Access Compliance Report

Public Rights-of-Way

(Curb Ramps)

Intersection ID: 21548	Main Street: OLD_PROVIDENCE_RD	Cross Street: PROVIDENCE_RD	Location: S
ADA ID: 45BED57F3186	Ramp Type: IslandPerp	Initial Pass/Fail: Fail	Overall Compliance: No
		Severity Score: 12.5

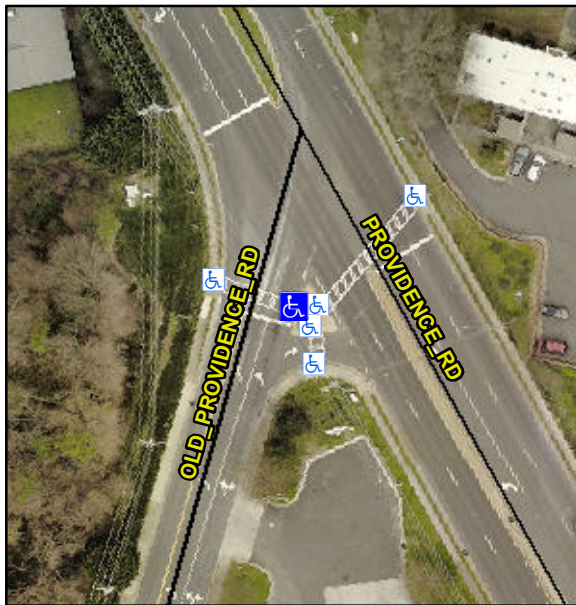
Not Found, R304.5.3

Compliance	Description	Data	Compliance	Description	Data
N/A	Ramp Length (in)	48.0	Yes	Ramp Slope (%)	6.8
Yes	Ramp Width (in)	48.0	No	Ramp XSlope (%)	5.3
N/A	Flare Type LT	N/A	N/A	Flare Type RT	N/A
N/A	Flare Slope LT (%)	N/A	N/A	Flare Slope RT (%)	N/A
N/A	Flare Traversable LT?	N/A	N/A	Flare Traversable RT?	N/A
N/A	Landing Length (in)	N/A	N/A	DWS Provided?	N/A
N/A	Landing Width (in)	N/A	N/A	DWS Contrast?	N/A
N/A	Landing Slope (%)	N/A	N/A	DWS Length (in)	N/A
N/A	Landing X Slope (%)	N/A	N/A	DWS Full Width?	N/A
N/A	Landing Curb? (Y/N)	N/A	N/A	DWS Offset (in)	N/A
N/A	Shared Landing?	N/A			
N/A	Gutter Ponding?	N/A	N/A	Gutter Slope (%)	N/A
N/A	Gutter Lip Ht (in)	N/A	N/A	Gutter X Slope (%)	N/A
N/A	Painted X Walk1?	Yes	N/A	Painted X Walk2?	N/A
	X Walk 1 Direction	To NW		X Walk 2 Direction	N/A
N/A	X Walk 1 Width (in)	70.0	N/A	X Walk 2 Width (in)	N/A
	X Walk 1 Slope (%)	1.9		X Walk 2 Slope (%)	N/A
	X Walk 1 X Slope (%)	1.9		X Walk 2 X Slope (%)	N/A

Possible Solutions:

Remove & Replace Entire Ramp.
